LAUREATE PARK PHASE 6

SUMMARY

<p>Updated: March 23, 2015</p>

DEVELOPMENT PLAN

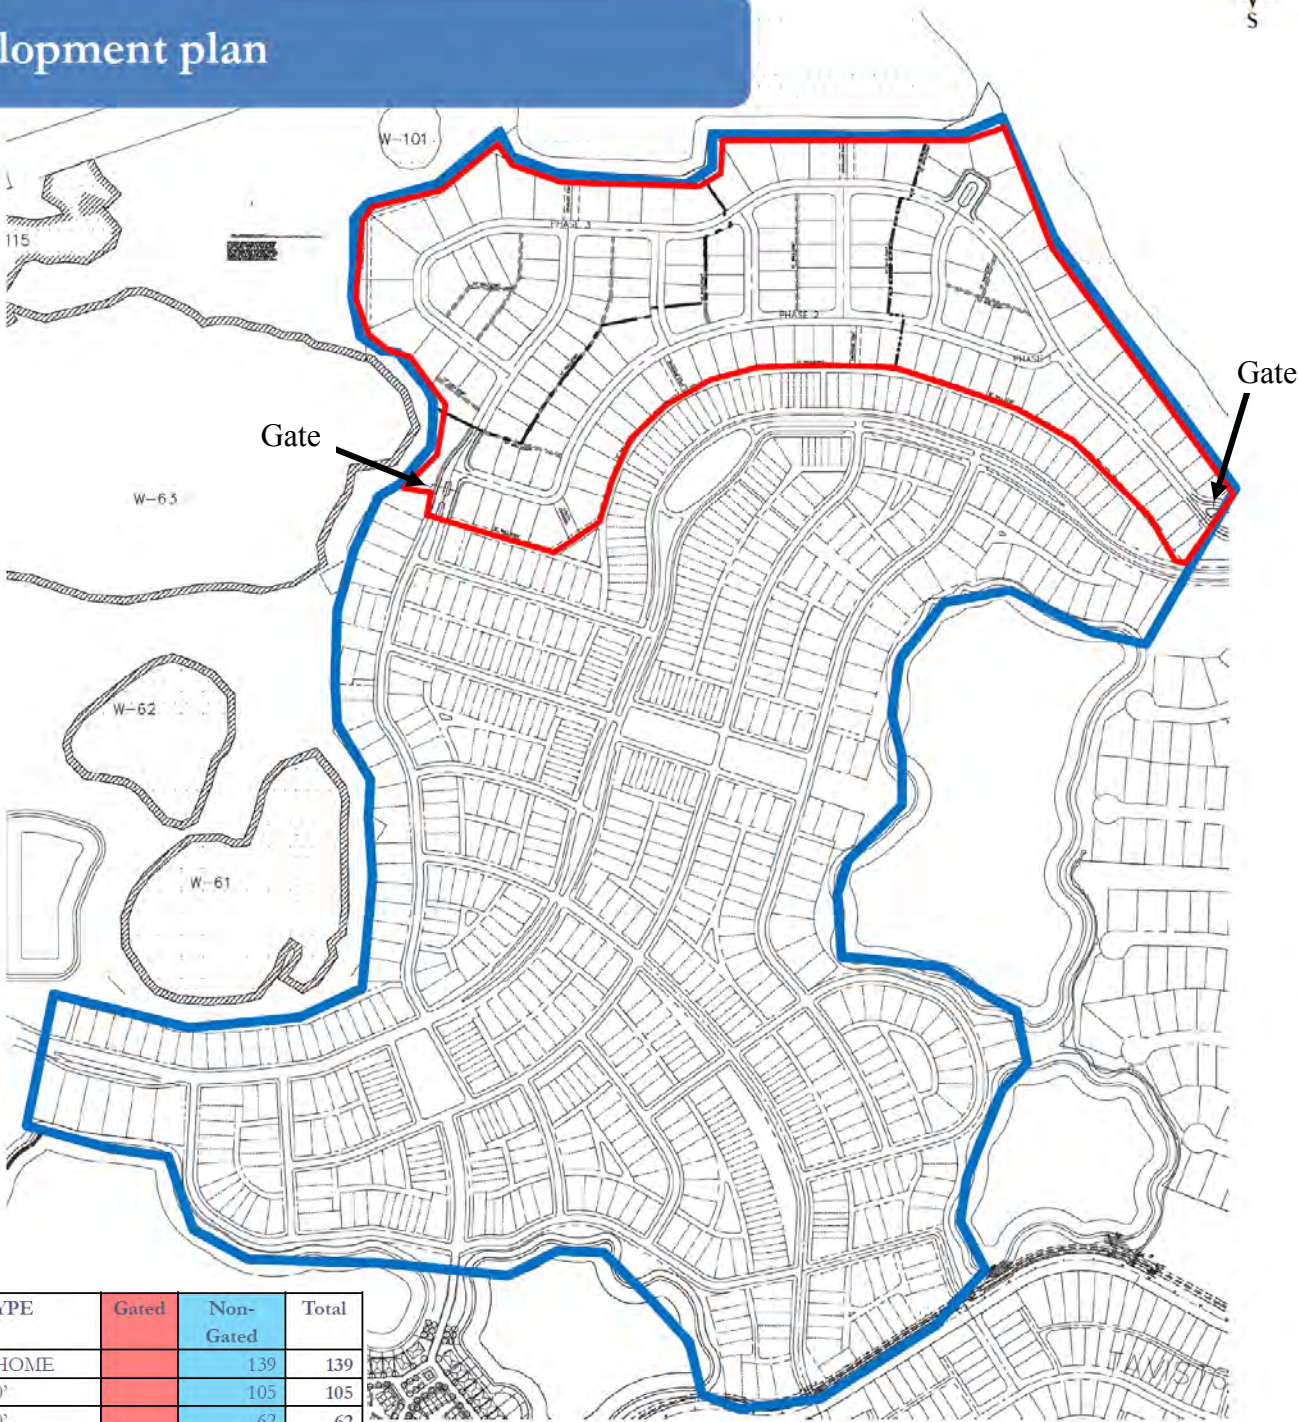
- If the lots south of Wetland #61 is rear loaded, add alley to the roadway map. This can be address at the Preliminary Plat stage.
- Show alley cross section for lot numbers 79, 80, 81, 251, 252, 253, 254, 255, 256, 382, 383, 384. This can be address at the Preliminary Plat stage.
- During the Preliminary Plat review, the City's Solid Waste Division and Fire Department shall review the alley conditions throughout the development to determine if a solid waste truck and/or fire truck can maneuver within the alleys.

TYPE "5" MODIFIED SECTION WITH TRAIL /PARKING
69' ROW

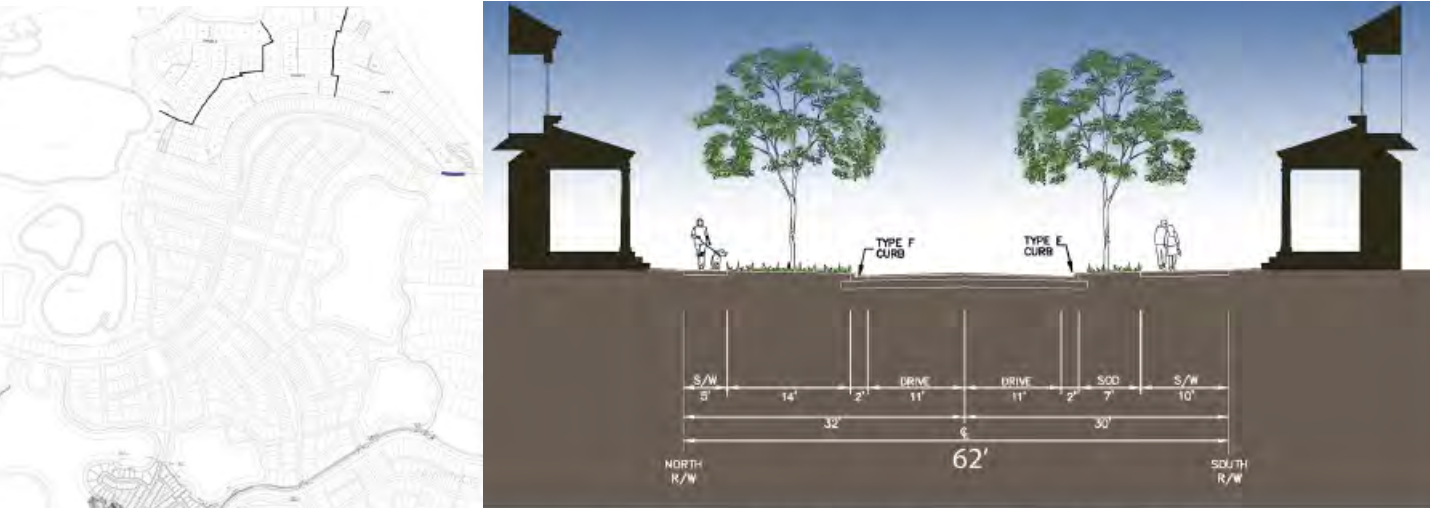
2. Section Type 5 w/Trail and w/o Trail:
 - Both of these sections shall include a 5' wide bike lane in each direction since they tie into Section Type A and are part of the main east-west roadway.

TYPE "B" PARKWAY ONE WAY
48,5' ROW

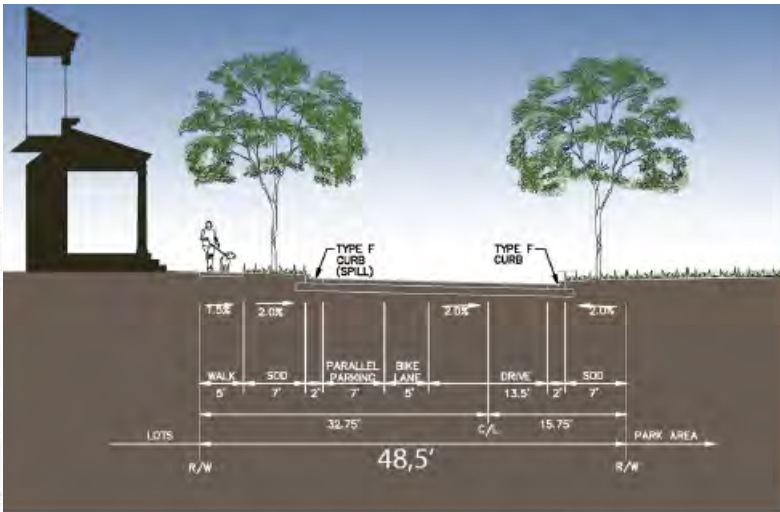
3. Section Type B:
 - The curb along the park shall be FDOT Type F. Flush curbs shall not be used outside of the alleyways.
 - A 5' sidewalk shall be provided on the park side of the road if a continuous sidewalk through the park is not constructed.
